Project Name **St. Michael's Hospital Avera**

Addendum # **3**

Date **5-05-14**

SUBJECT: STRUCTURAL ADDENDUM
PROJECT: AVERA ST. MICHAELS
TYNDALL, SD

1 BRICK RECESS DETAIL
 1" = 1'-0"

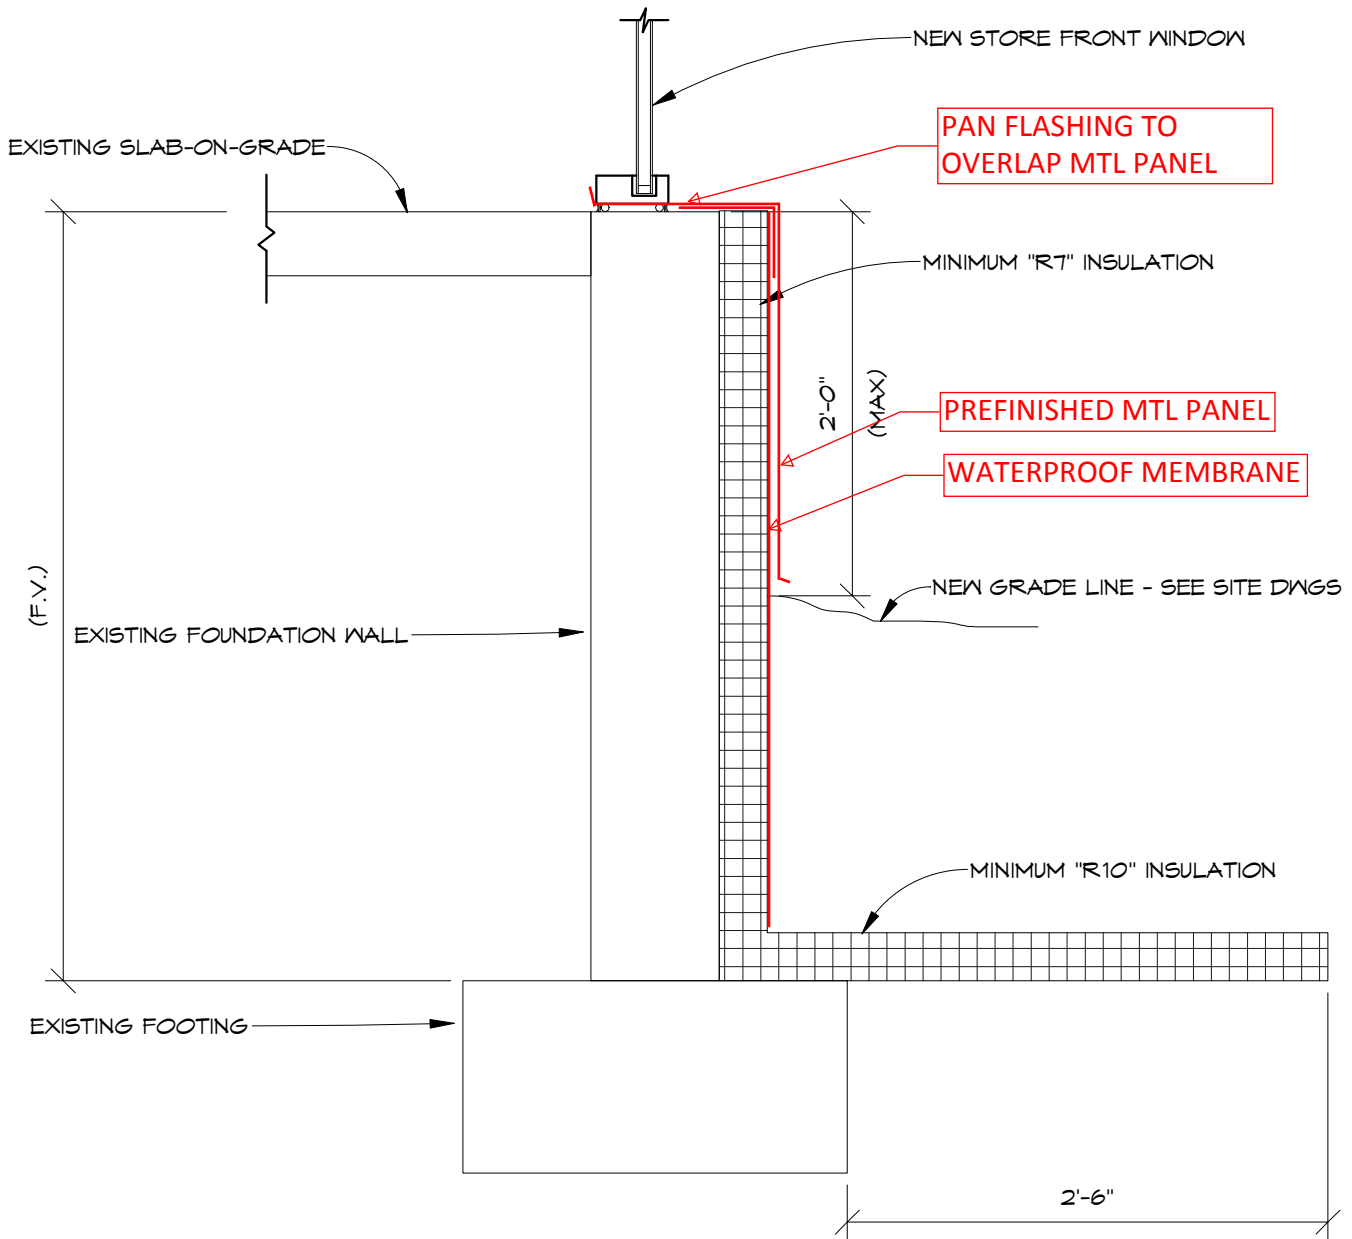
REFER TO STRUCTURAL
